DRAWING AMENDMENTS

RESPONSE AND REMARKS

Serial No. 10/821,452

FIG. 1

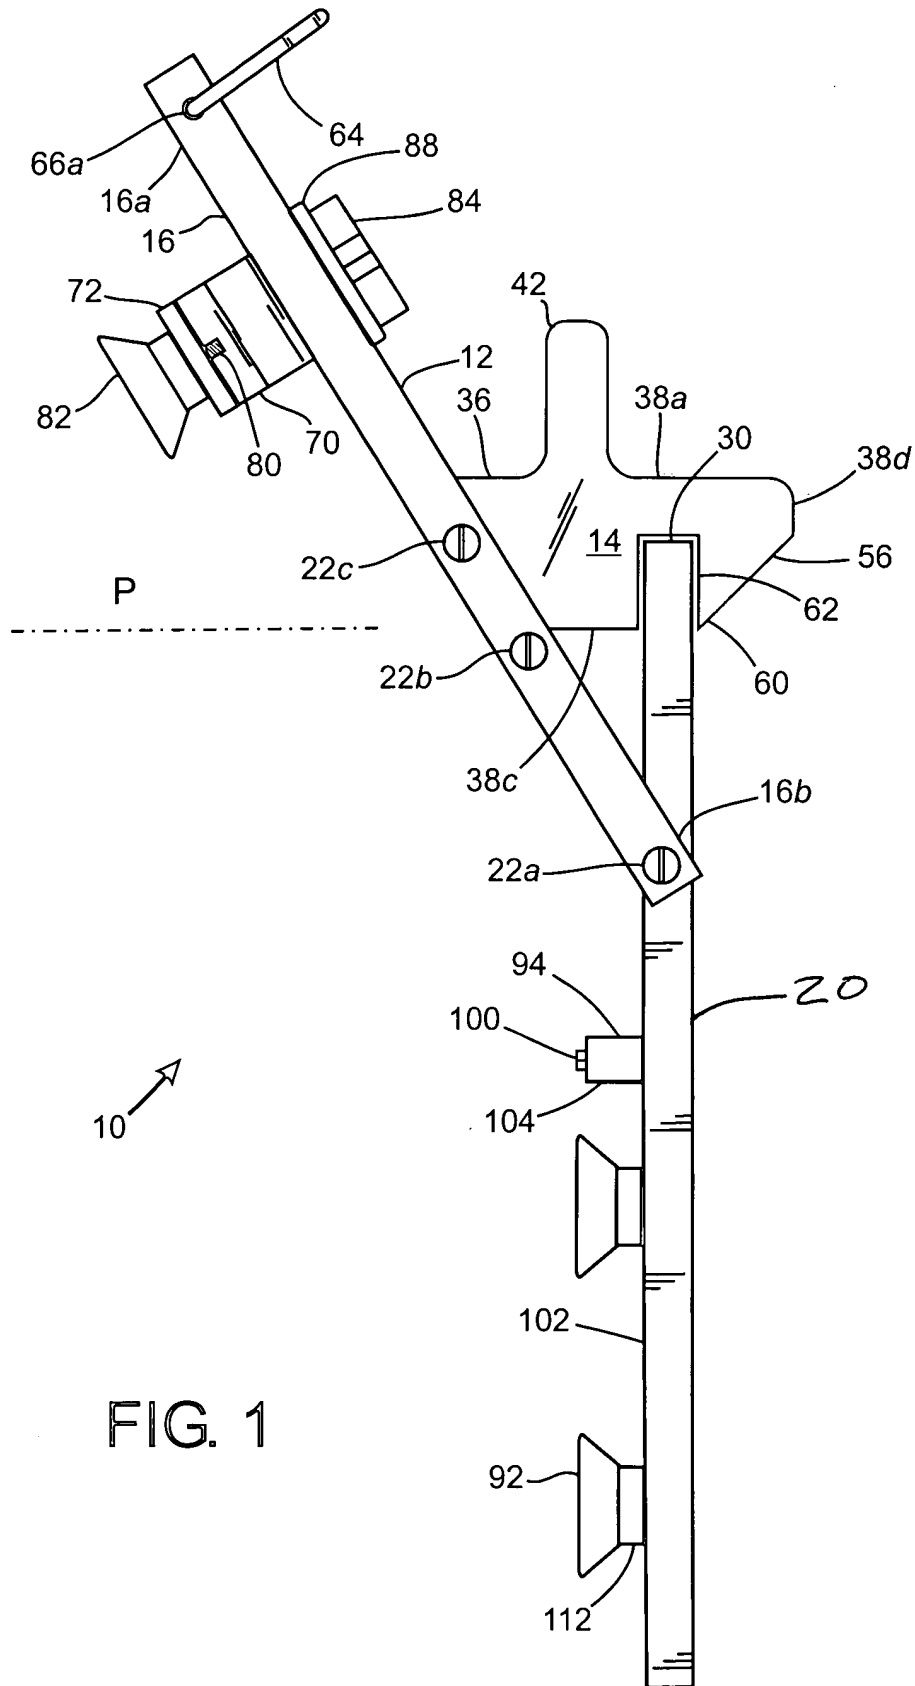
Applicant notes herein a change to a drawing as originally submitted in the application for patent. More specifically, Figure 1 has been amended to conform to the Examiner's requirement to include a numeric reference in association with a vertical support member.

The Examiner has objected to a drawing as originally submitted with the application for patent for failure to comply with 37 CFR 1.84(p)(5), particularly of which relates to an omitted reference sign in association with a vertical support member as specifically mentioned in the specification.

The vertical support member in Figure 1, as presently amended, is now shown with a numeric reference (20).

In response, Applicant has amended Figure 1 to include numeric reference "20" as

being associated with a vertical support member, of which is specifically described under the heading entitled "Detailed Description of the Preferred Embodiment."
